Mosaic Fertilizer, LLC
13830 Circa Crossing Drive
Lithia, FL 33547

Re: New Wales Facility
SAP No. 1 2011 Turnaround Projects
BART Permit 1050059-061-AC

**RE: MOSAIC FERTILIZER, LLC – NEW WALES FACILITY
PROJECT NO. 0570059-061-AC
BEST AVAILABLE RETROFIT TECHNOLOGY EXEMPTION APPLICATION
WITHDRAWAL OF MAY 4 LETTER SUBMITTAL REVISING SCENARIO A**

**RE: MOSAIC FERTILIZER, LLC – NEW WALES FACILITY
PROJECT NO. 0570059-061-AC
BEST AVAILABLE RETROFIT TECHNOLOGY EXEMPTION APPLICATION**

Revised Flow Diagram – SAP Nos. 1 and 2
New Wales Facility, Mosaic Fertilizer, LLC

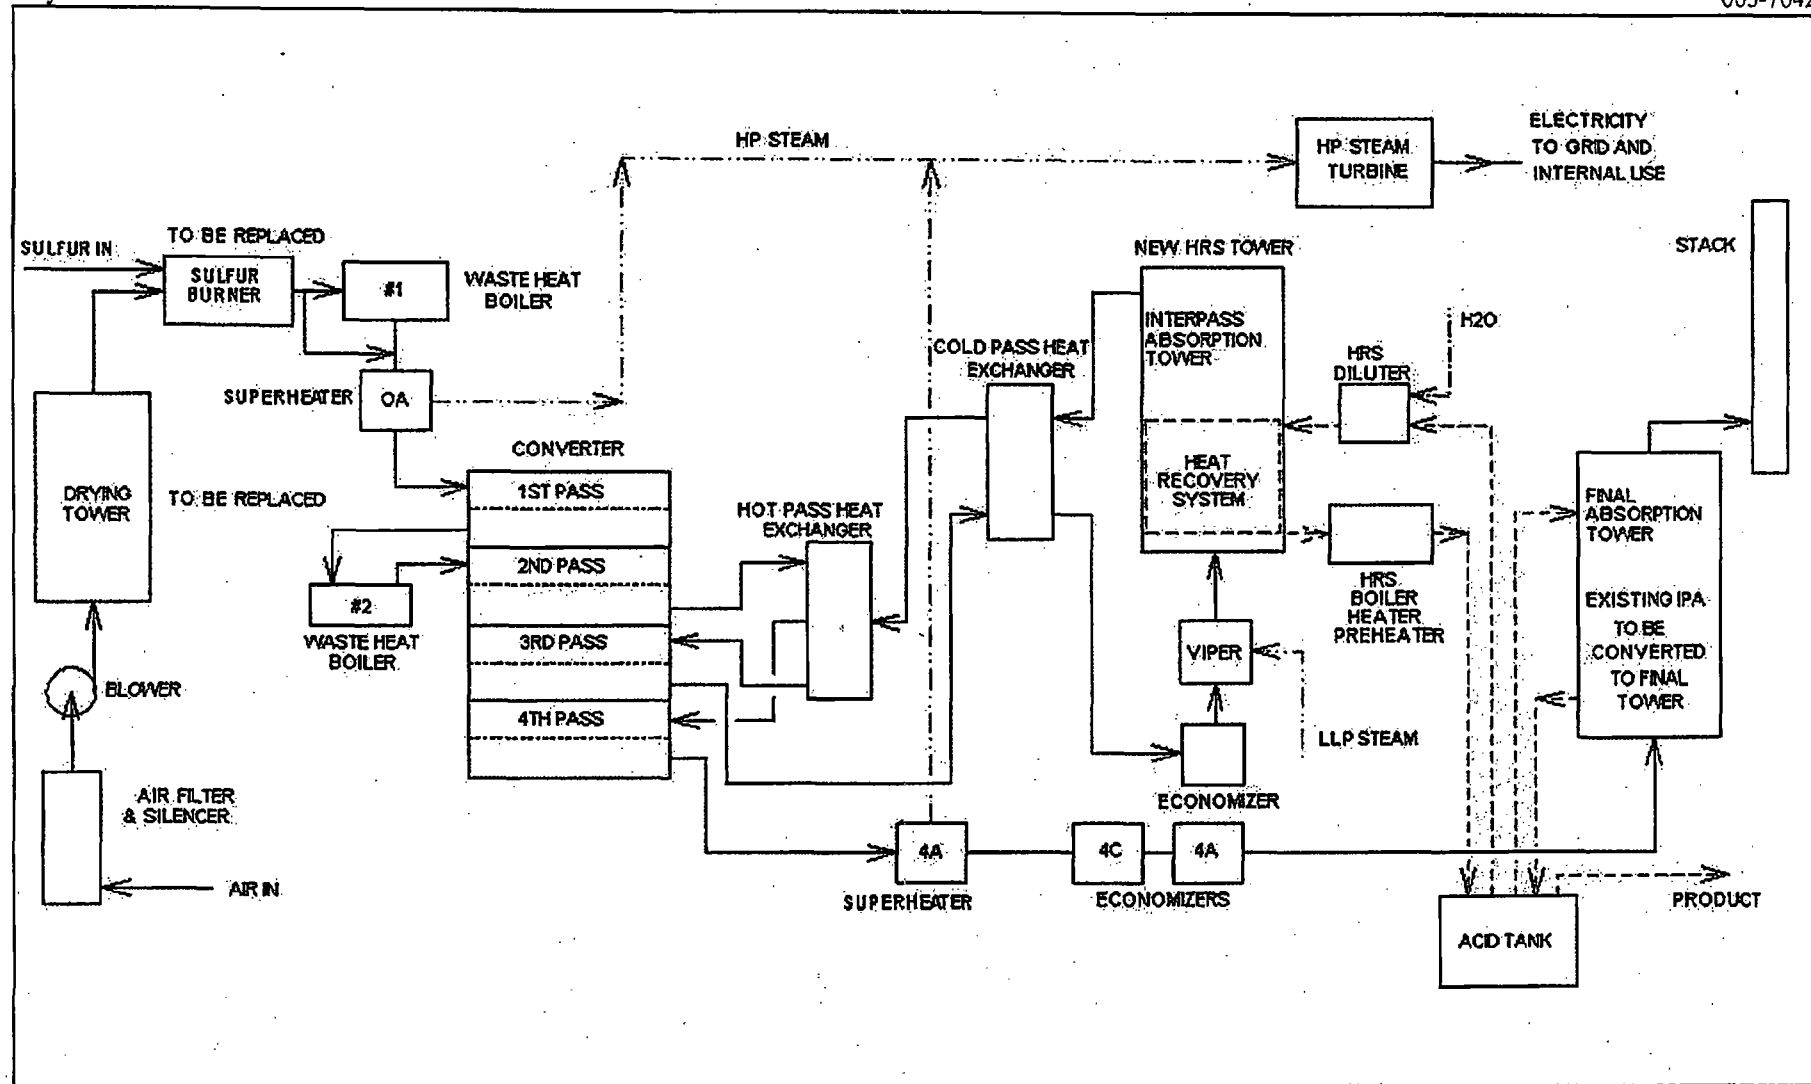
Pursuant to your telephone conversation with Mr. Rama Iyer, a revised flow diagram is included with this submission showing further detail regarding the HRS for SAP Nos. 1 and 2. As shown in the diagram, the HRS is shown as the new HRS Tower with the HRS dotted block shown with

the HRS diluter, HRS boiler, heater, preheater, and Viper block flows in and out of it. The Viper block is essentially to absorb SO₃ using low-pressure steam which provides heat that can be recovered. The HRS diluter, as the name implies, provides for water and acid balance into the system. Thus, with these HRSs in effect, the high-pressure steam in the superheaters is enhanced to provide for overall higher heat utilization, allowing increases in the overall system electricity generation.
